# ROCKDALE CITY COUNCIL

## Planning Assessment Report

<b>Application Number:</b>	DA-2015/279
<b>Date of Receipt:</b>	3 February 2015
<b>Property:</b>	19 Willis Street, WOLLI CREEK NSW 2205 SP 37252 Lot 1 DP 802439
<b>Owner:</b>	The Prop Of Strata Plan 37252
<b>Applicant:</b>	Lateral Estate Pty Limited
<b>Proposal:</b>	19-21 Willis Street, WOLLI CREEK NSW 2205 - Integrated Development - Construction of two x eight (8) storey residential flat buildings comprising 67 residential units, basement parking and demolition of existing structures.
<b>Recommendation:</b>	Approved
<b>No. of submissions:</b>	Nil
<b>Author:</b>	Pascal van de Walle
<b>Date of Report:</b>

**Figure 5 - Area exceeding the maximum 28m building height shown dotted red (north-east elevation).**

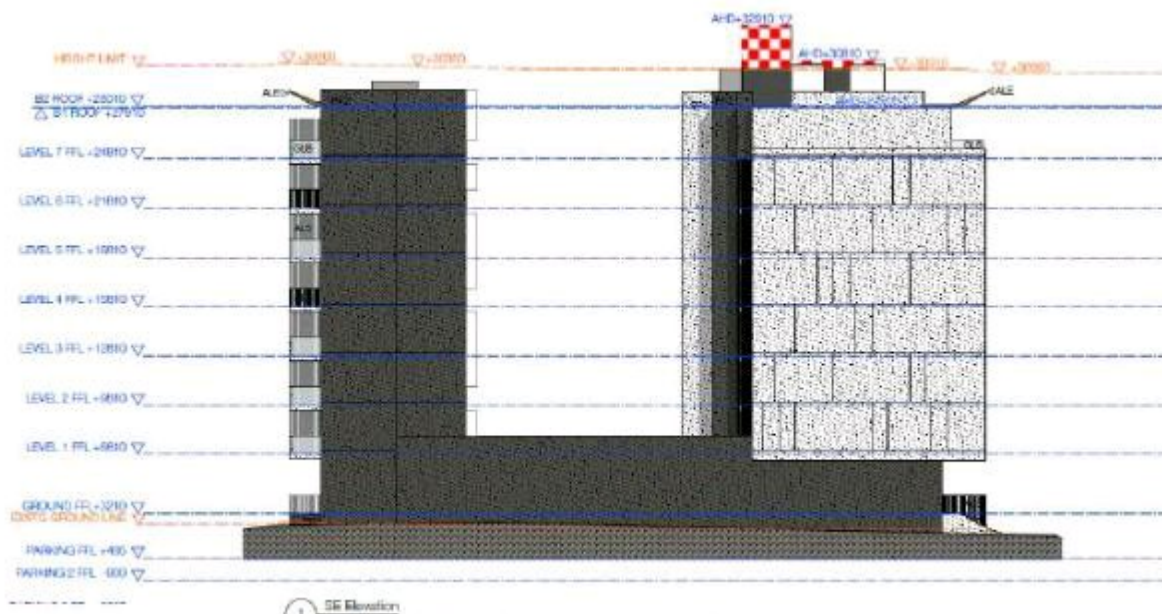
The proposal was amended to include an area of communal open space at roof top level of Building 1 that includes lift access and a canopy for weather protection. The amendment was made to address issues raised by the Design Review Panel and Council relating to amenity for future residents. The maximum height of the fire stairs and canopy is 28.5m and the maximum height of the the top of the lift is 30.6m. Therefore the proposal exceeds the maximum 28m height permitted by clause 4.3 of RLEP 2011 by between 0.5m (1.8%) and 2.6m (9.3%) (see **Figure 5** and **Figure 6**).

The applicant has submitted a detailed justification to the proposed variation to the height development standard. It is the applicant's position that compliance with the standard is unreasonable and unnecessary, and that the proposal is acceptable in the circumstance of the case for the following key reasons:

**Figure 9 - Section prior to reduced GFA (i.e. current proposal)**

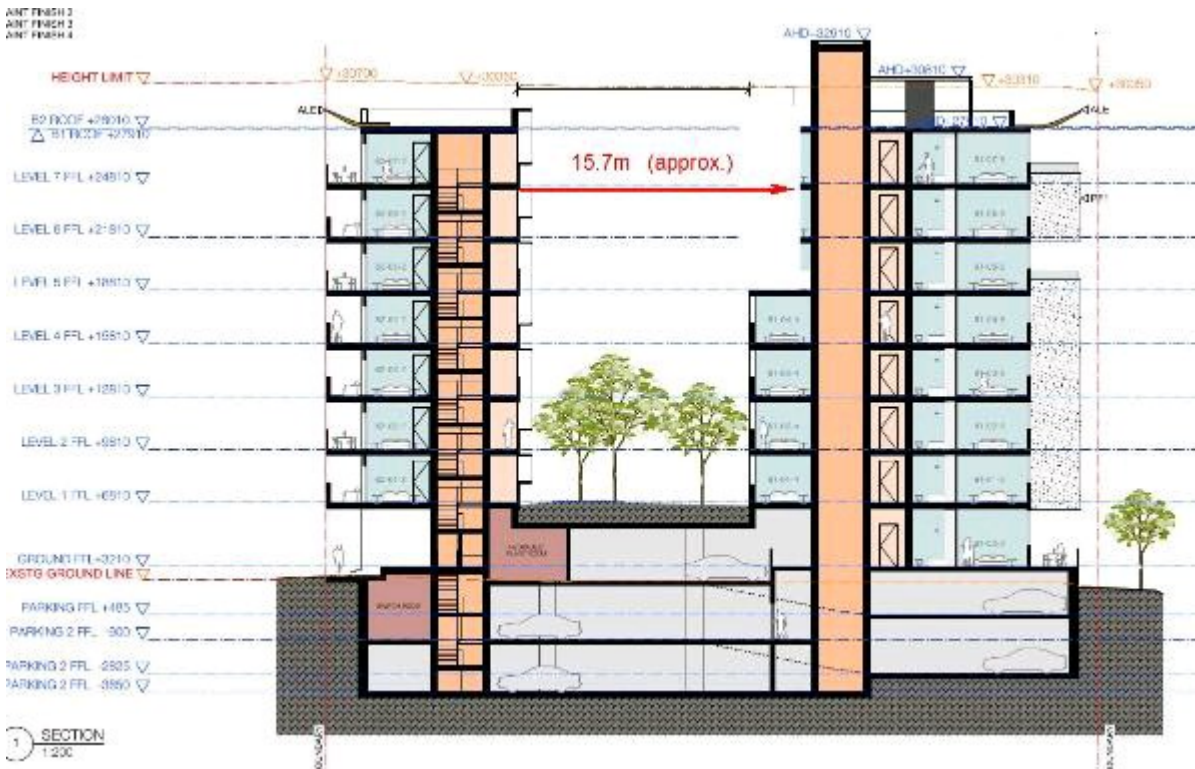
A reduction of the GFA as shown in **Figure 8** and **Figure 10** below is therefore recommended on the 6th, 7th and 8th floor of Building B1 (i.e. Levels 5, 6 & 7 on the plans).

**Figure 10 - Section after reduced GFA.**

The above modification would comprise a reduction in the GFA of 95.3m<sup>2</sup>, and would result in a GFA of 5,185m<sup>2</sup> and an FSR of 2.94:1 (or an FSR of 2.86:1 and GFA of 5,026m<sup>2</sup> if calculated in accordance with the applicant's interpretation of GFA). It would also result in a building separation of approximately 15.7m between the two proposed buildings at these upper levels.

The modification would require internal reconfiguration of the six (6) affected units, and a draft condition requires that this be undertaken in a manner that would ensure compliance with the minimum unit sizes in the 'rules of thumb' in the RFDC as well as Council's parking requirements.
